# MMD Public Hearing on Chino CCP

Gila Resources Information Project

April 21, 2026

# Other Relevant Permits

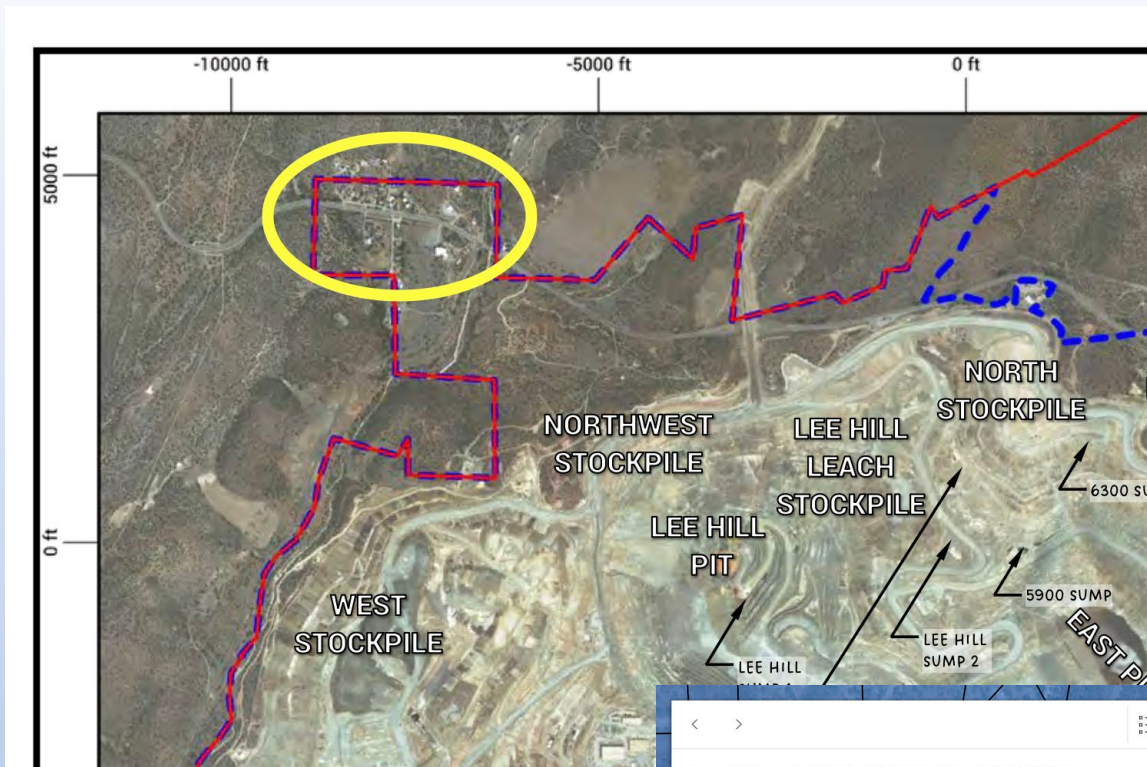
- BLM – What's the status of the revised Mine Plan of Operations and NEPA process to account for new Kessell Stockpile and other changes?
- NMED – Supplemental Discharge Permit for Closure - DP-1340 to protect groundwater.
- NMED – Ensure conditions are in DP-1340 for surface water quality protection until state permitting program is operational.
